Access Compliance Report

Public Rights-of-Way

(Curb Ramps)

Intersection ID: 42794	Main Street: SIDNEY_CREST_AV	Cross Street: ERWIN_TRACE_DR	Location:	N
ADA ID: 440AD082C8E4	Ramp Type: BlendTrans1	Initial Pass/Fail: Fail	Overall Compliance: No	Severity Score: 10

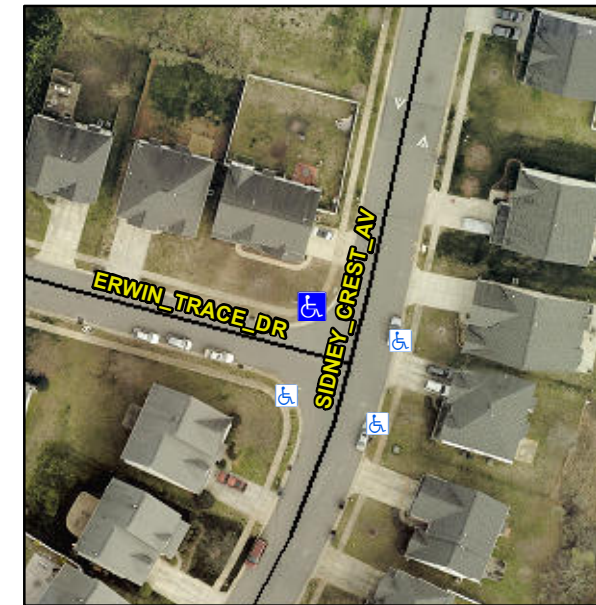
Not Found, R304.5.1, R304.5.3

Compliance	Description	Data	Compliance	Description	Data
N/A	Ramp Length (in)	47.5	Yes	BlendTrans Slope (%)	4.6
No	Ramp Width (in)	41.5	No	BlendTrans XSlope (%)	4.1
N/A	Flare Type LT	N/A	N/A	Flare Type RT	N/A
N/A	Flare Slope LT (%)	N/A	N/A	Flare Slope RT (%)	N/A
N/A	Flare Traversable LT?	N/A	N/A	Flare Traversable RT?	N/A
N/A	Landing Length (in)	N/A	N/A	DWS Provided?	N/A
N/A	Landing Width (in)	N/A	N/A	DWS Contrast?	N/A
N/A	Landing Slope (%)	N/A	N/A	DWS Length (in)	N/A
N/A	Landing X Slope (%)	N/A	N/A	DWS Full Width?	N/A
N/A	Landing Curb? (Y/N)	N/A	N/A	DWS Offset (in)	N/A
N/A	Shared Landing?	N/A			
N/A	Gutter Ponding?	N/A	N/A	Gutter Slope (%)	N/A
N/A	Gutter Lip Ht (in)	N/A	N/A	Gutter X Slope (%)	N/A
N/A	Painted X Walk1?	No	N/A	Painted X Walk2?	No
	X Walk 1 Direction	To S		X Walk 2 Direction	To E
	X Walk 1 Width (in)	N/A		X Walk 2 Width (in)	N/A
	X Walk 1 Slope (%)	2.1		X Walk 2 Slope (%)	2.3
	X Walk 1 X Slope (%)	1.8		X Walk 2 X Slope (%)	3.6

N/A	Ramp inside XWalk1?	N/A	N/A	Ramp inside XWalk2?	N/A
	Road Slope (%)	2.6		Clear Space?	N/A
	Road X Slope (%)	0.4	N/A	Clear Space to XWalk (in)	N/A
N/A	Any Obstructions?	N/A	N/A	Storm Grate/Utility Hazard?	N/A
	Obstruction Type			Storm Grate/Utility Type	
		N/A			N/A
			Yes	Surface Condition? (G/P)	Good
			No	Curb Slope (%)	16.0

Remove & Replace Curb Ramp With Two New Directional Ramps or Equivalent.
